Objection To :- The Uniting Kingscliff Redevelopment (SSD47105958)

I live at 37 Drift Court Kingscliff, am a direct neighbour to the proposed Uniting Kingscliff Redevelopment (SSD47105958) and object to the development proposal based the items listed below.

Figure 1: The view into my backyard living space from Building D

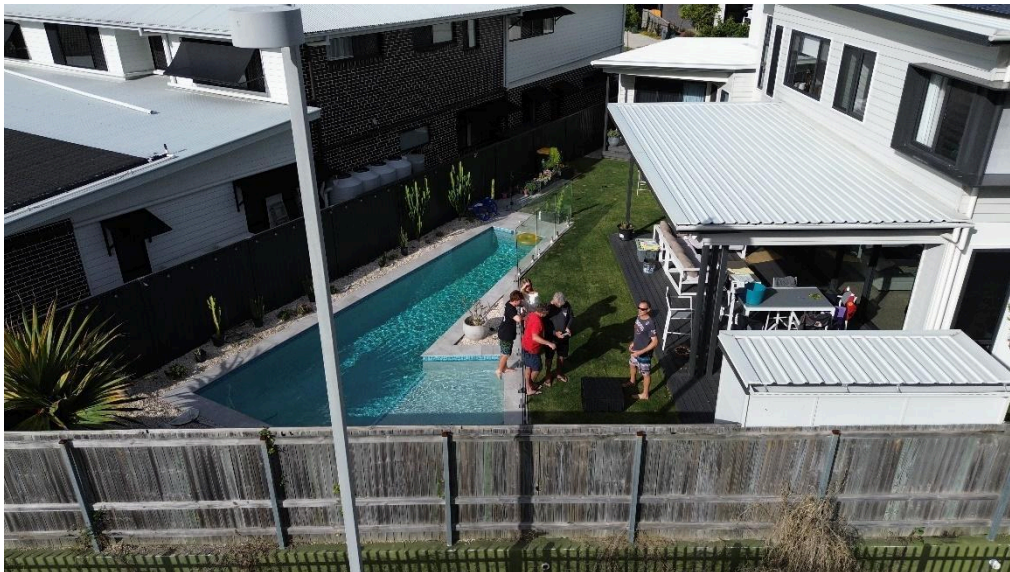
Due to constraints because of the shape of our land, our home is designed to maximise the natural benefits of light, warmth and air is towards the northwest and west. The proposed development will look with more than 100 large windows and verandahs back into our living, entertaining, pool and open spaces (Refer to photographs below)

I have a teenage daughter who uses our outdoor space on a regular basis with her friends, and this will potentially see a number of people looking INTO our personal space.

Figure 7: Water level in front of 3 Drift Court

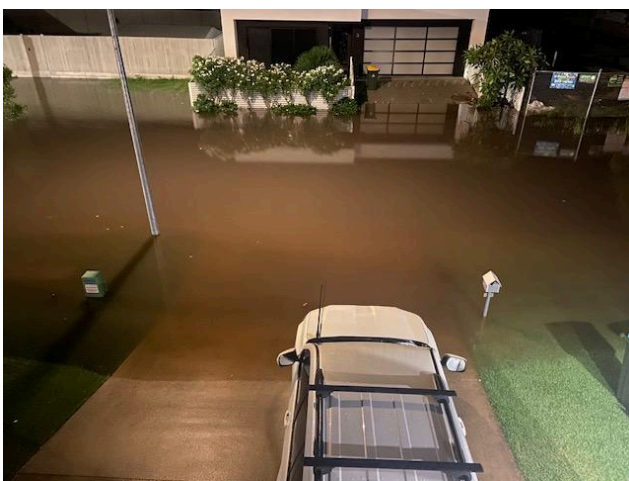
The flood assessment included in the EIS, in my opinion (as a qualified and experienced Engineer) is grossly inadequate. The diagram below depicts the flooding impact within Drift Court as a result of the February 2022 rain, supported by the photographs below.

Figure 10: Light entering the master bedroom, even with curtains

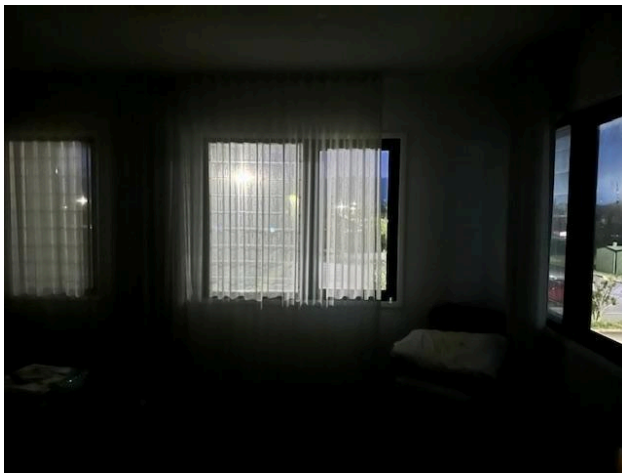
Light, as with noise, has already been an ongoing issue for us in the past. In particular the balconies, veranda's and external areas will generate significant additional light after hours into our living and bedroom spaces. Below are photos of the EXISTING light that spills into our spaces.

Figure 13: Revision to a 3 storey proposed development with 35 and 37 Drift Court in front

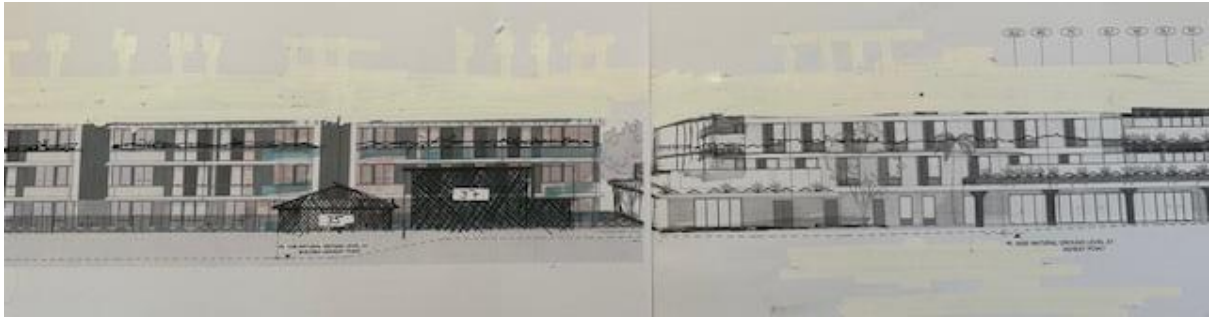
The need to fill the site is a development constraint that must be factored into the potential yield of a development when dealing with building height. Four storeys are not **as of right on the site** and if a three storey height was adopted, the development inclusive of the filling would comply with the height limit also present in the Kingscliff Development Plan. Refer to Figures 12 and 13 below on how a four storey to three storey would change our immediate outlook.

Below we have overlaid our homes against the project's building heights.
